Project: GPC6, C2012668-02 Task Order #39 Dallas  
CBD Second Light Rail Alignment  
(D2 Subway)

Subject: **FINAL DRAFT** Technical Memorandum No. 14 – **REVIEW**  
DART Internal Memorandum dated August 24, from Tad Heimburger titled “Lessons Learned on Tunnel Drainage”

FIGURE 3: DART D2 SUBWAY PROFILE

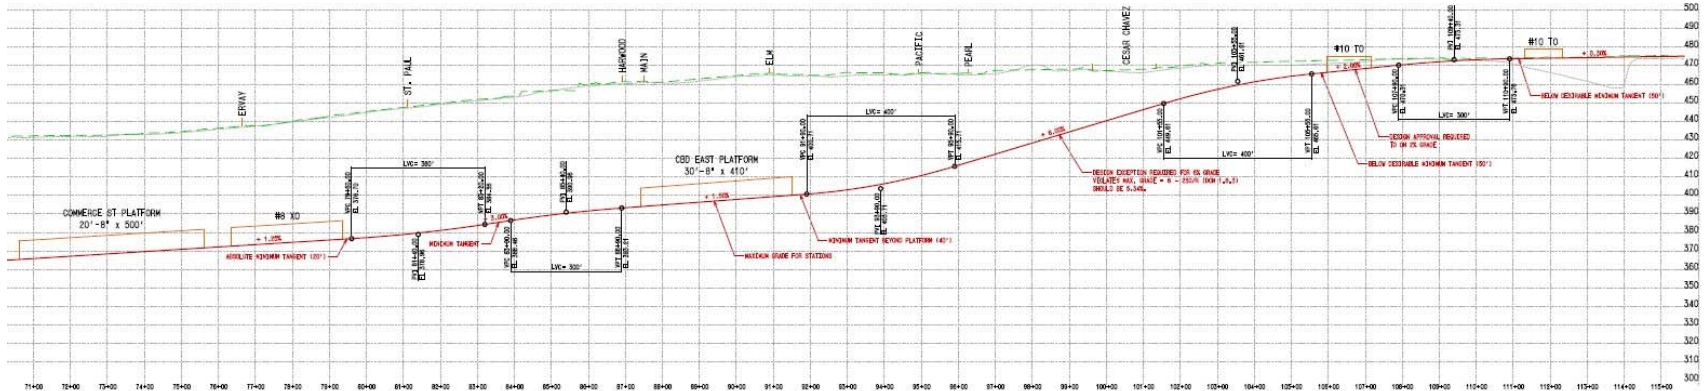
Update Figure 3 with the latest Track Profile.

**FIGURE 4: MINED CAVERN STATION**

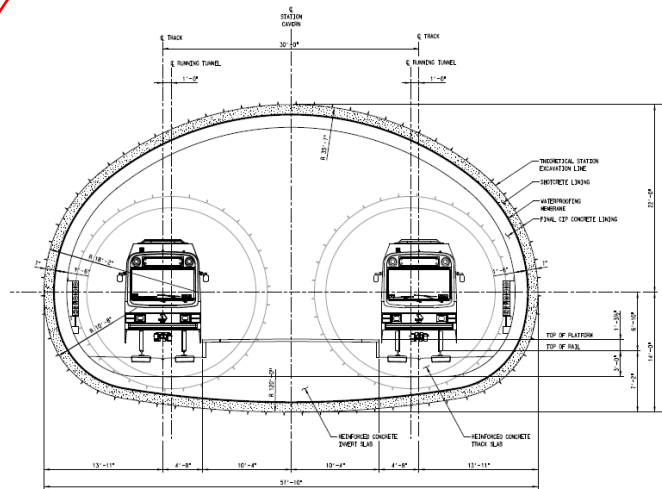
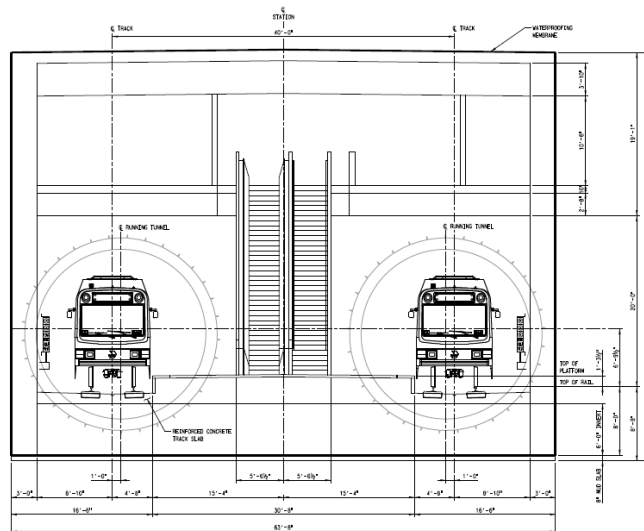
Update to 20%
